**PLANNING DEPARTMENT ADMINISTRATIVE PUBLIC HEARING
SUMMIT COUNTY, UTAH
March 7, 2024**

Subject: 243 Woodside Avenue
Application: PL-23-05841
Author: Lillian Zollinger, Planner II
Date: March 7, 2024
Type of Item: Historic District Design Review

Subject: 1049 Lowell Avenue
Application: PL-24-06032
Author: Lillian Zollinger, Planner II
Date: March 7, 2024
Type of Item: Modification of Historic District Design Review

EAST ELEVATION
1/4" = 1'-0"

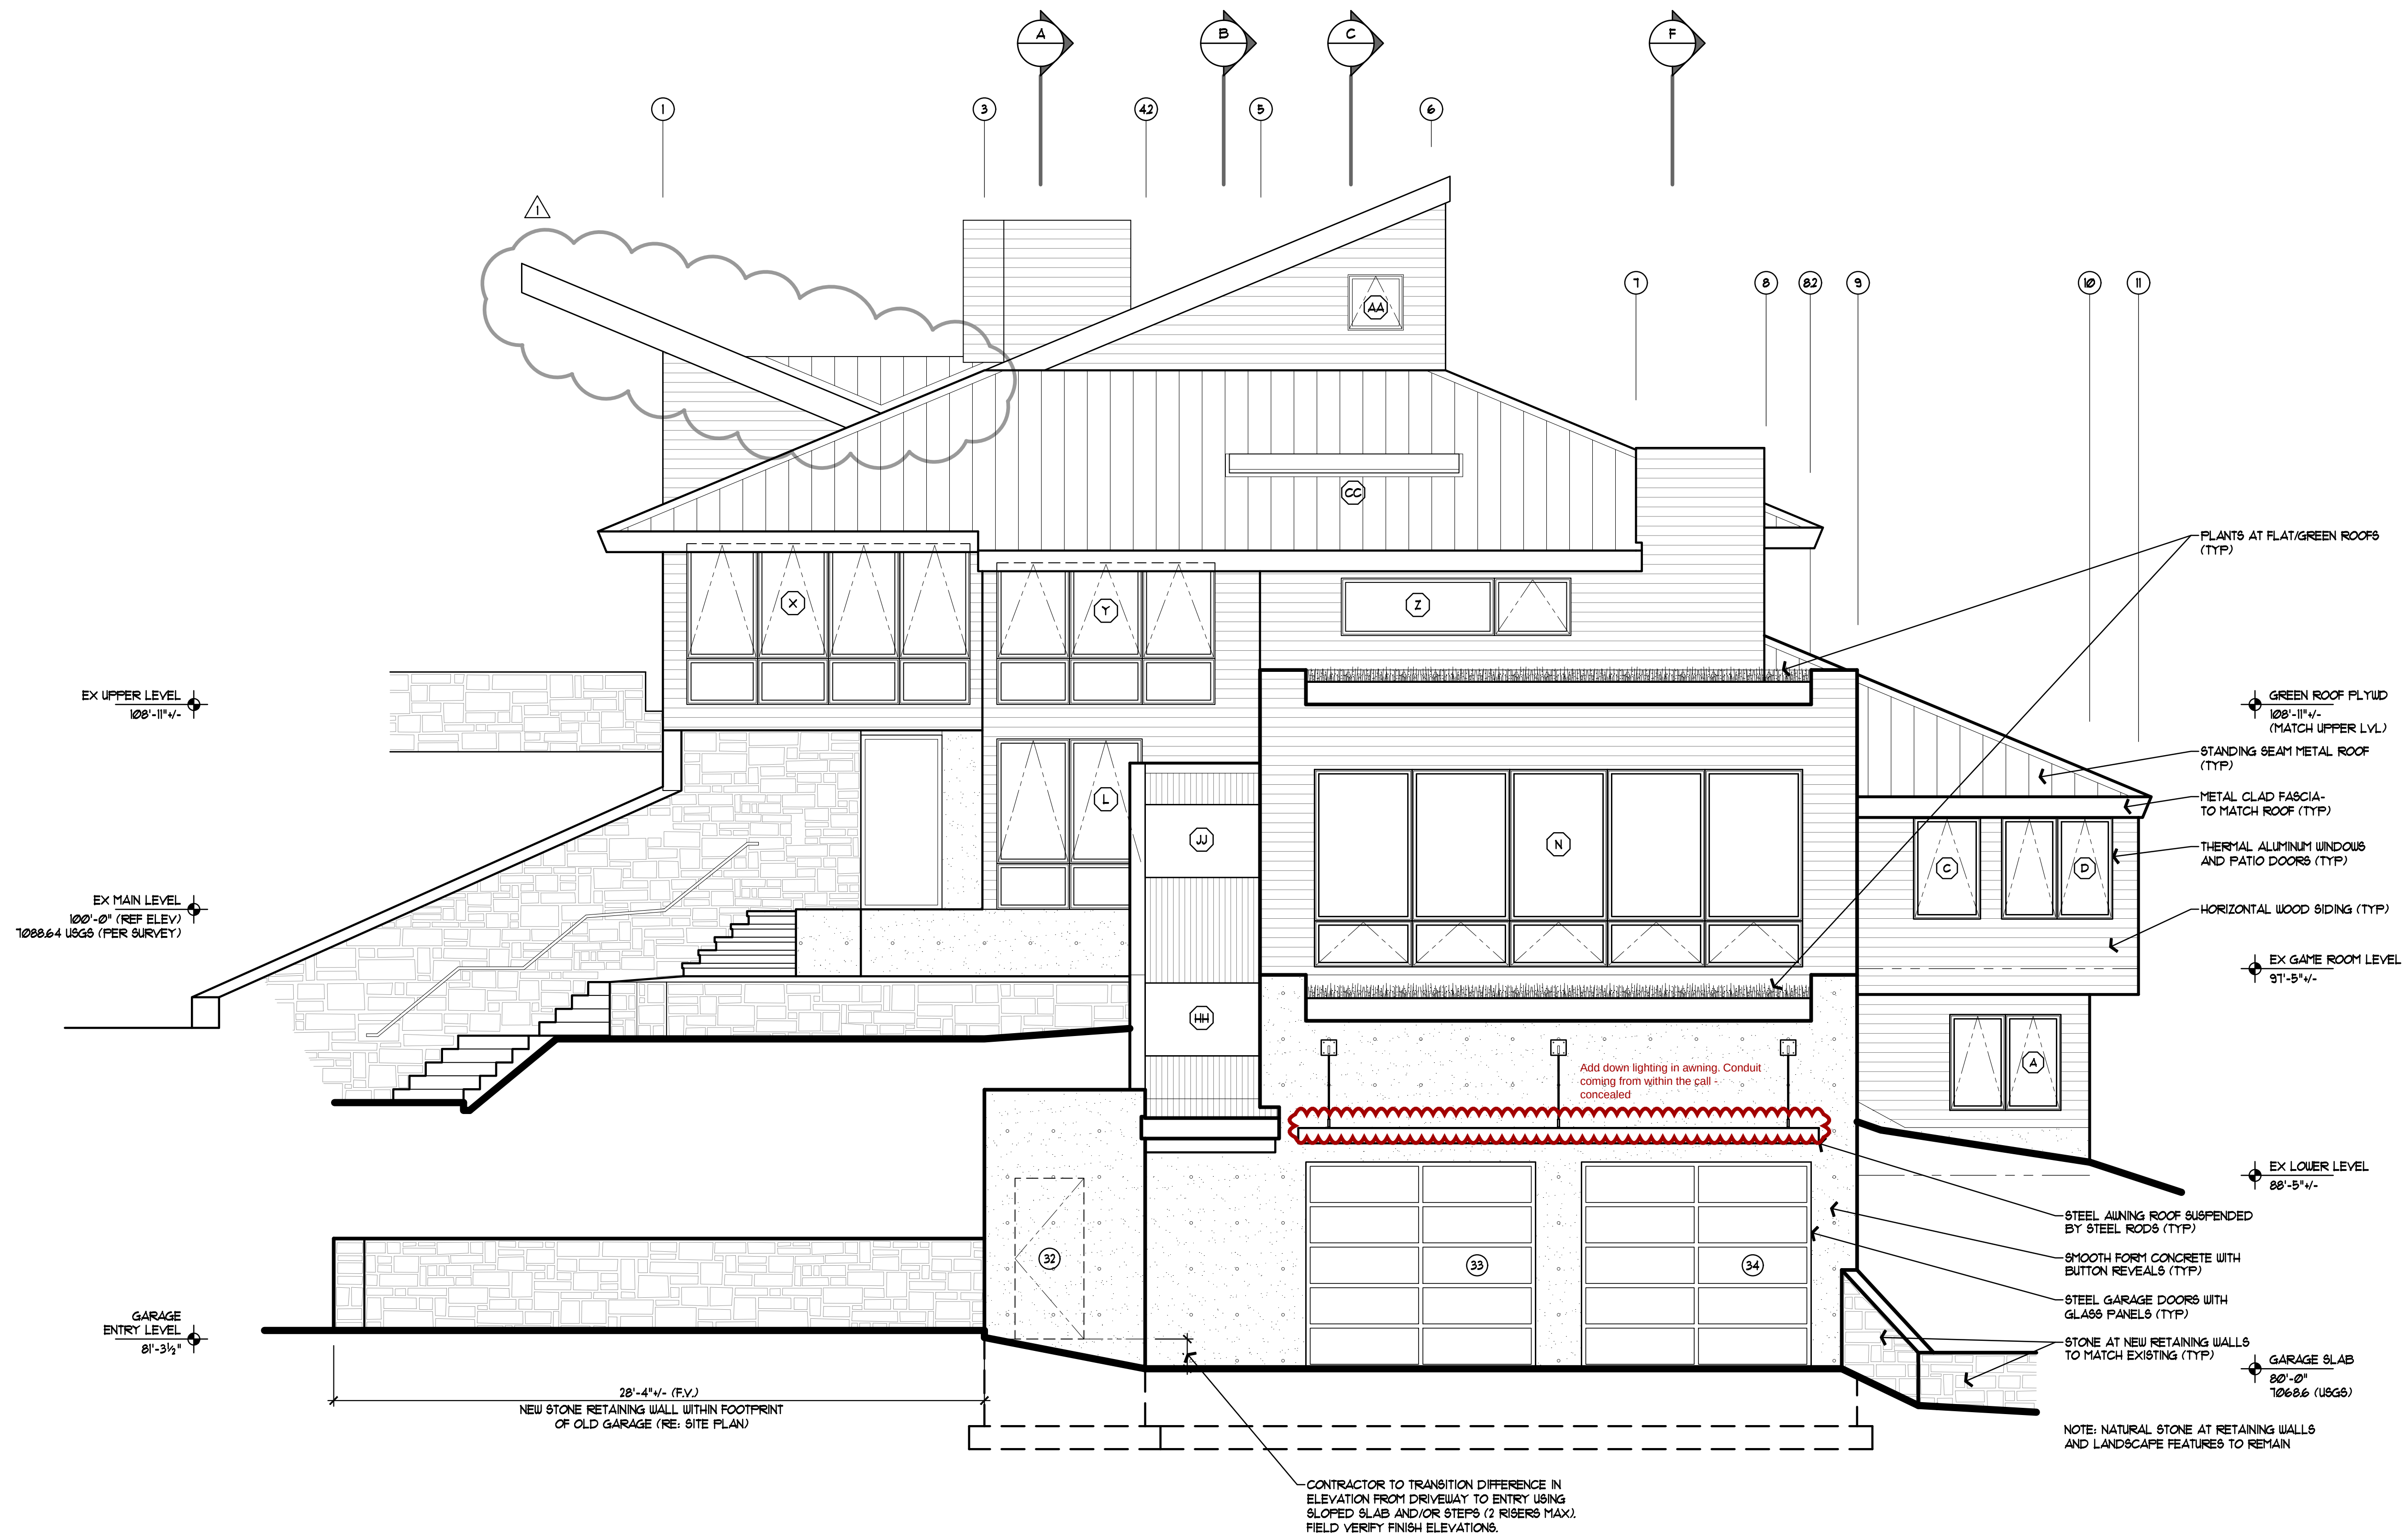
On January 23, 2024, the Applicant applied for a HDDR Modification. The Applicant requests approval for a roof modification in the rear. The previous gable roof was 14.9 feet tall, and the built inverted shed roof is 19.5 feet tall.

Figure 1. Proposed Front (East) Elevation

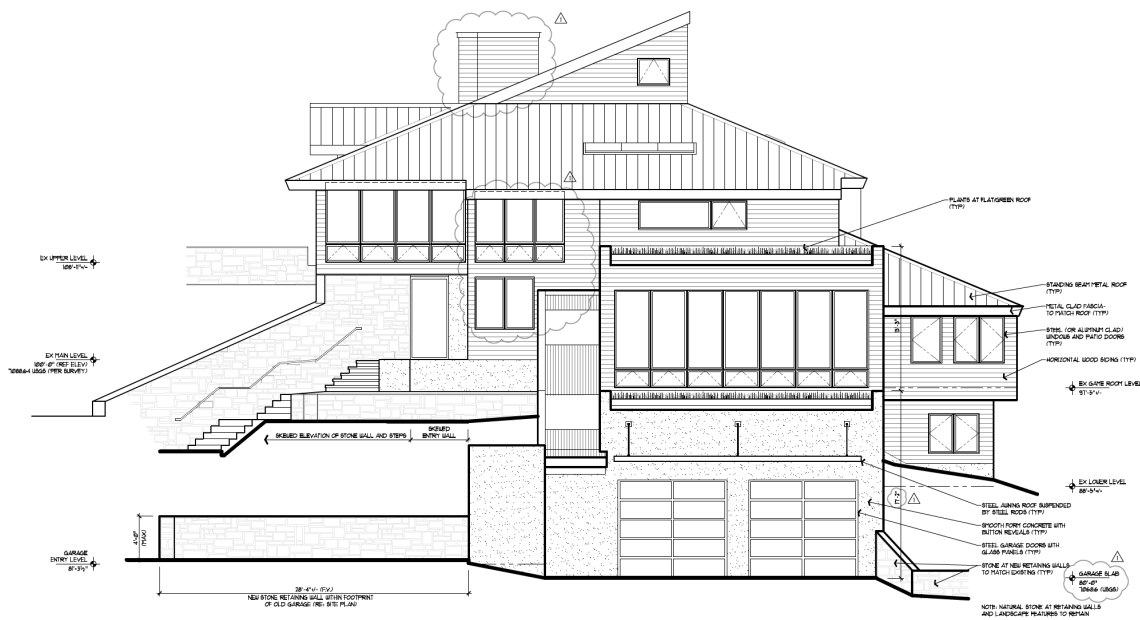
A. Universal Guidelines	Analysis of Proposal
Universal Guideline 1.	Complies; The proposal uses simple building forms, unadorned materials, and restrained ornamentation.
Universal Guideline 2.	Complies; The proposal does not directly imitate existing historic structures.
Universal Guideline 3.	Complies.

Universal Guideline 4.	Complies; The building massing and scale of the addition is compatible with historic structures as the modules of the addition are similar in scale to building proportions of Historic Structures in the Historic District.
Universal Guideline 5.	Complies; The proposal respects the existing topography as the building mass steps along with grade, and minimizes cut and fill and the use of retaining walls as the building structure itself acts as the majority of site retention.
Universal Guideline 6.	Complies.
Universal Guideline 7.	Complies; The scale and height of the proposed addition follows the predominant pattern of the streetscape.
Universal Guideline 8.	Complies; The size and mass of the proposed remodel and addition is compatible with the size of the site.
Universal Guideline 9.	Complies; No nearby Historic Sites are damaged.
Universal Guideline 10.	Complies.
Universal Guideline 11.	No new materials are proposed.
